**REVIEW OF ECOLOGICAL ASSESSMENT BY JAMES WARREN &
ASSOCIATES FOR A PROPOSED EXPANSION OF BP AUSTRALIA SITE
AT CHINDERAH: LOT 1 DP 1127741 AND LOT 2 DP 1010771**

Vegetation Assessment and Options

SITE LAYOUT - PROPOSAL E (OPTION 2)

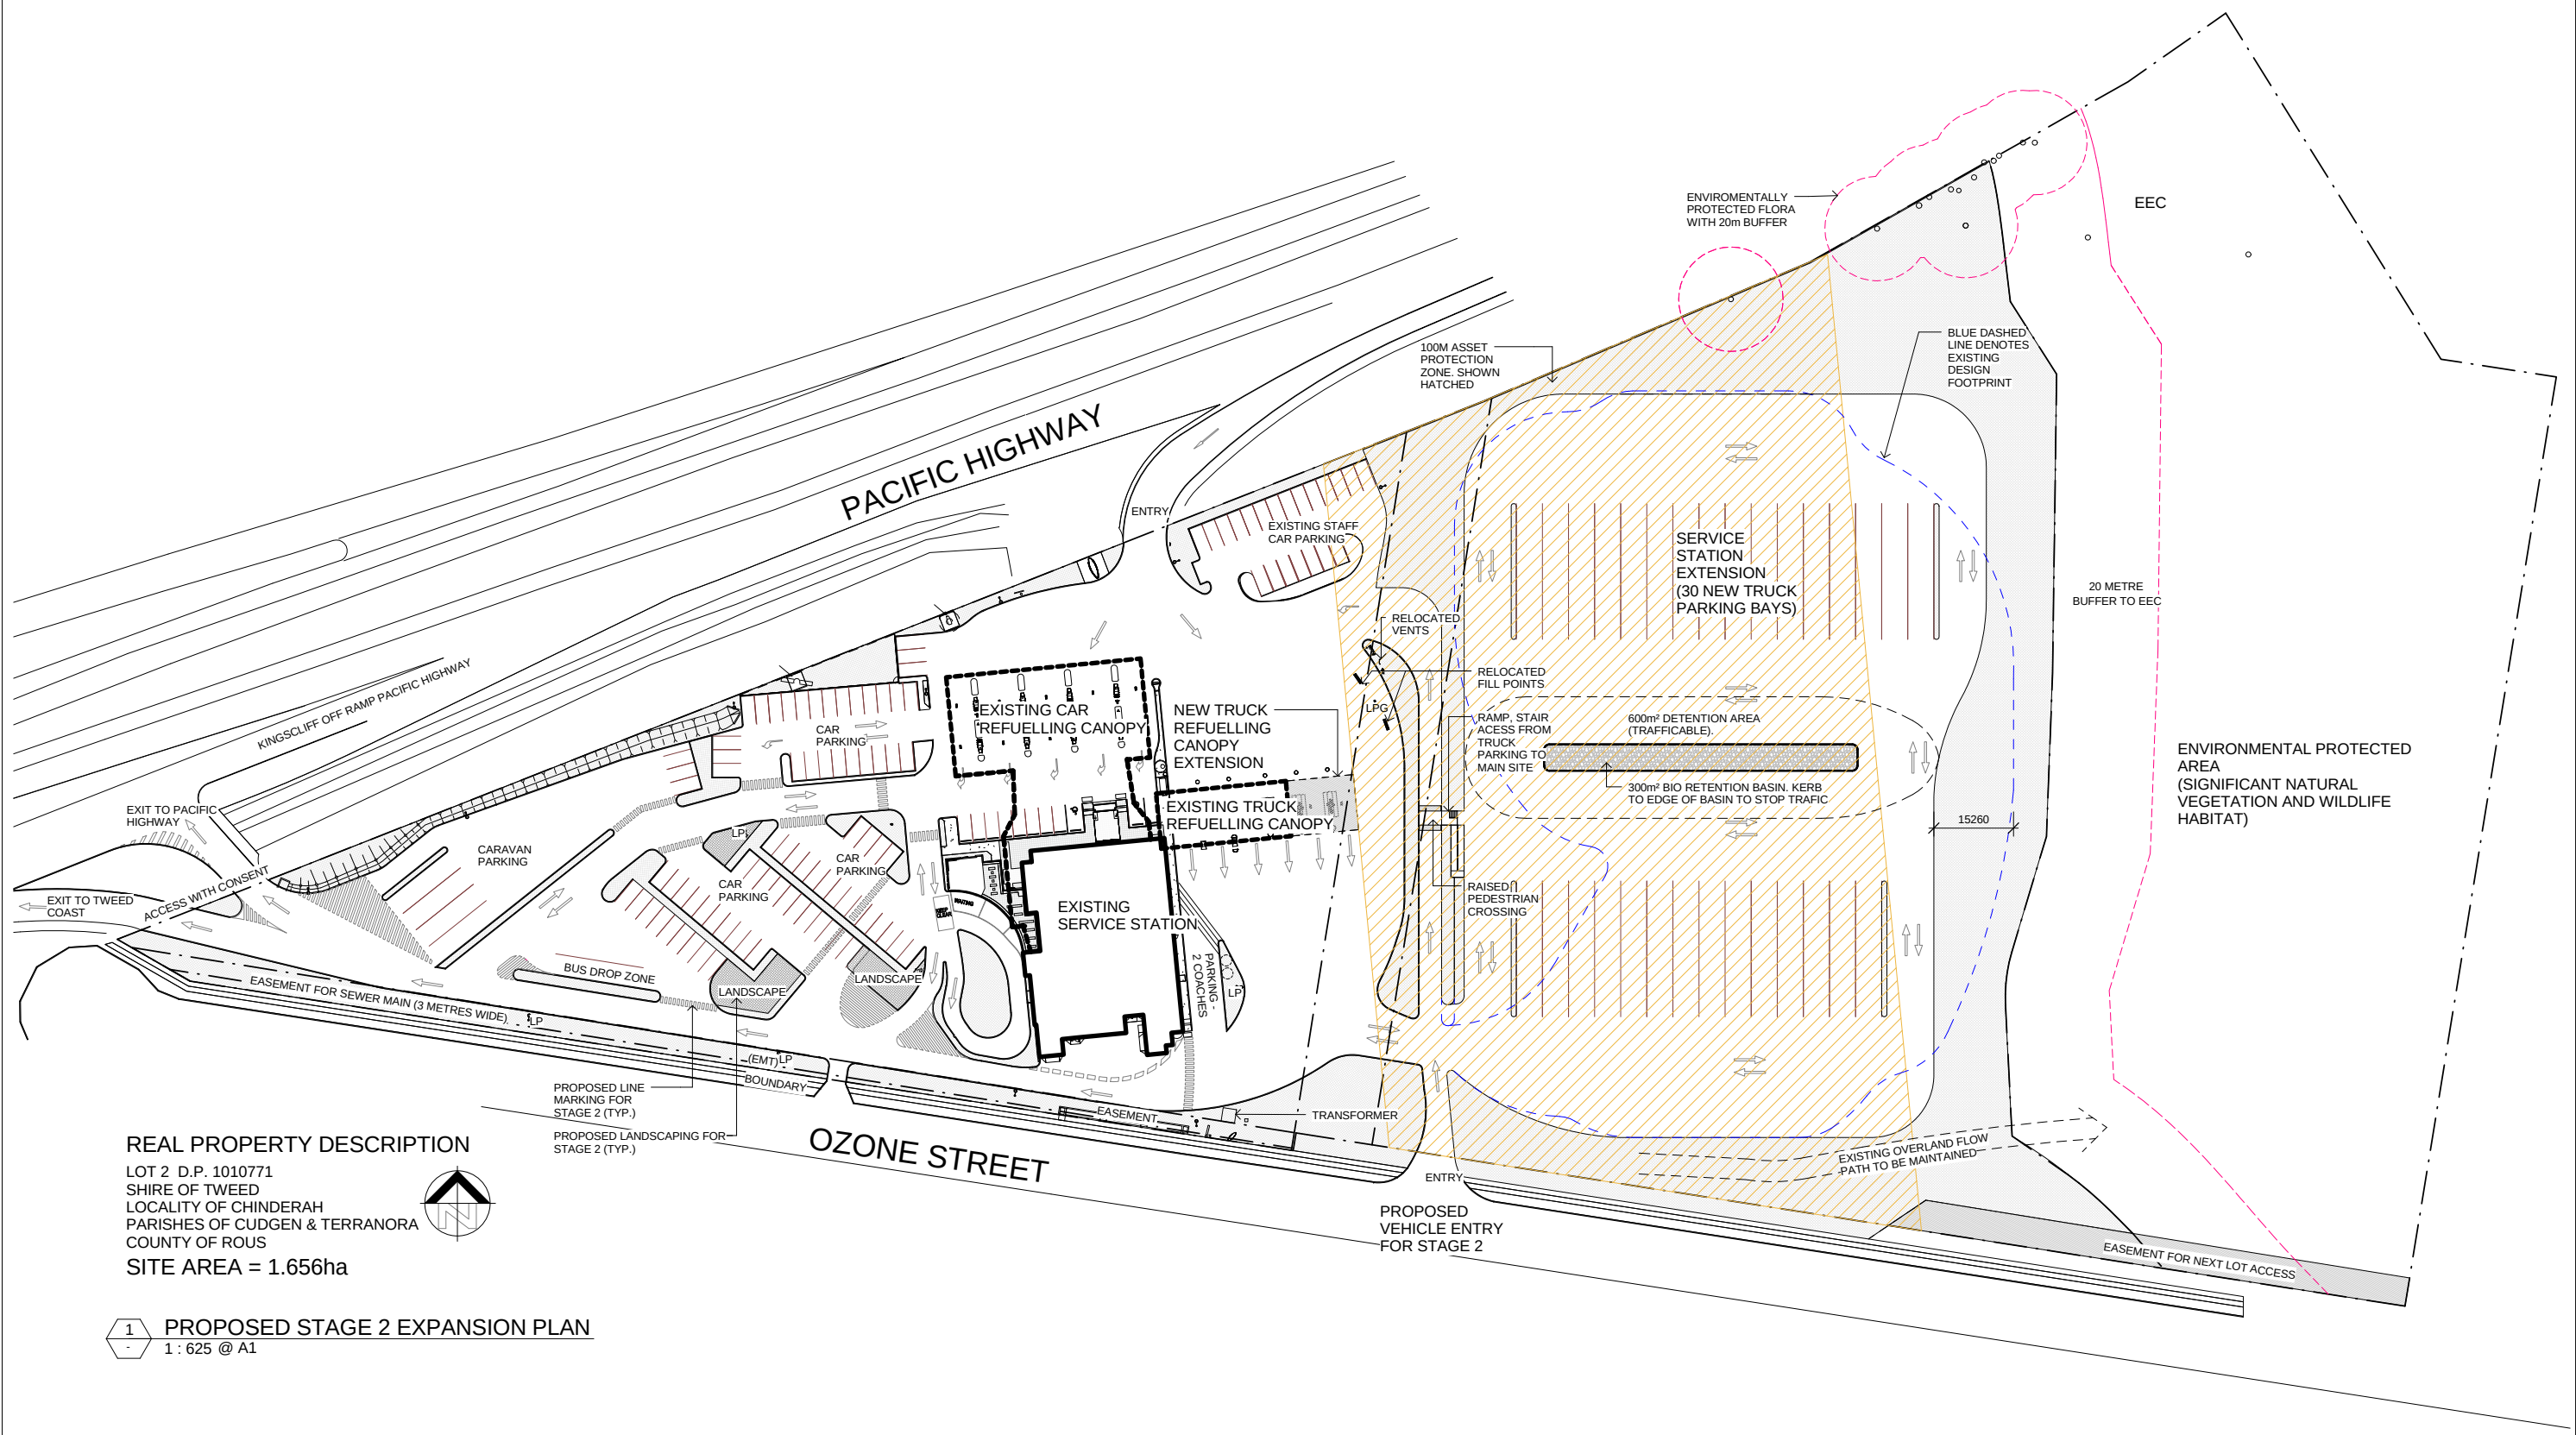
- Option 2: reduction in the area of vegetation removed from the northern boundary, to increase the buffer area between the development and the threatened *Acronychia littoralis* (Scented Acronychia) plants that are to be retained and fenced; and

Option 2 provides greater protection for the *Acronychia littoralis* (Scented Acronychia) plants. However, even under the current Proposal, the existing cluster of plants will be retained and protected in situ, with exclusion fencing installed. Despite the fencing, and the additional buffer proposed by Option 2, it is possible that the future longevity of this sub-population is at risk, due to its proximity to the Pacific Highway and associated edge-effects. For this reason, it is suggested that additional measures to offset the impacts on this threatened plant are employed, including propagation within the Conservation Area, as described further below.

OPTION 1

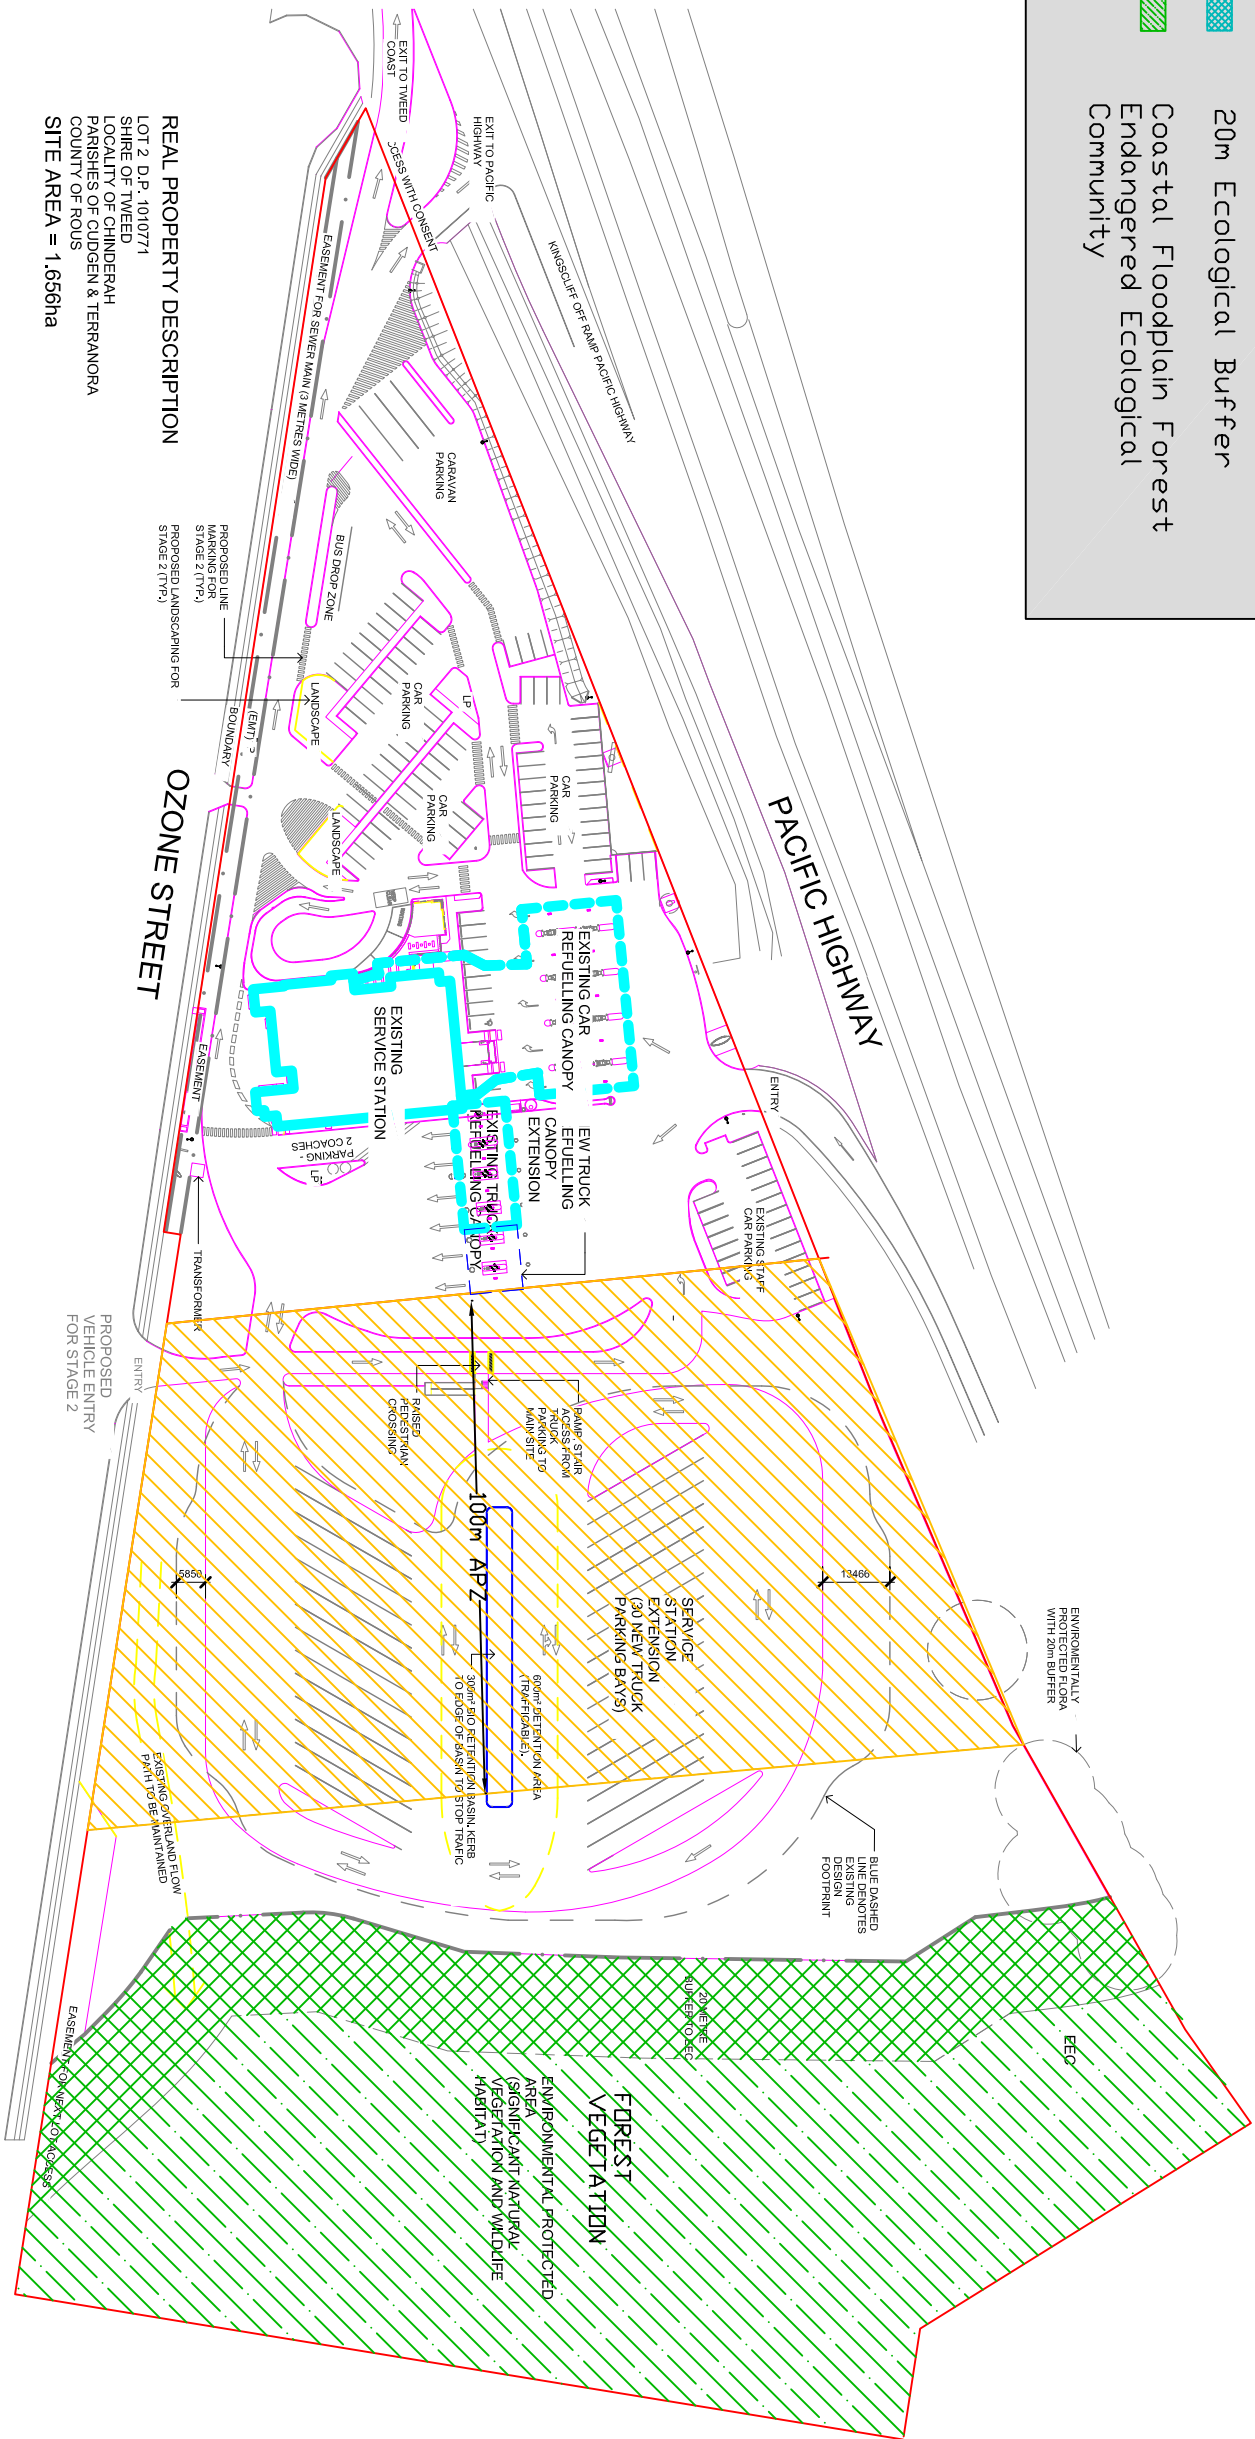
All three options have been assessed by a bushfire planning consultant (Bushfiresafe Aust 2014), and current legislation has been applied to indicate the location and extent of APZs. **Appendix C** to this letter provides the Asset Protection Zone Drawings prepared by Bushfiresafe (Aust). Each of the three options comply with the bushfire safety requirements. The APZ for each draft option can include the truck parking area, and there is no overlap with the buffer to the Conservation Area and TECs. The narrow strips of native vegetation (Community 5) that occurs to the south and also to the north of the development footprint, will be technically within the APZ, although no vegetation removal or fuel management activities will be required (pers comm. Wayne Hadaway, Bushfiresafe, 26/09/2014).
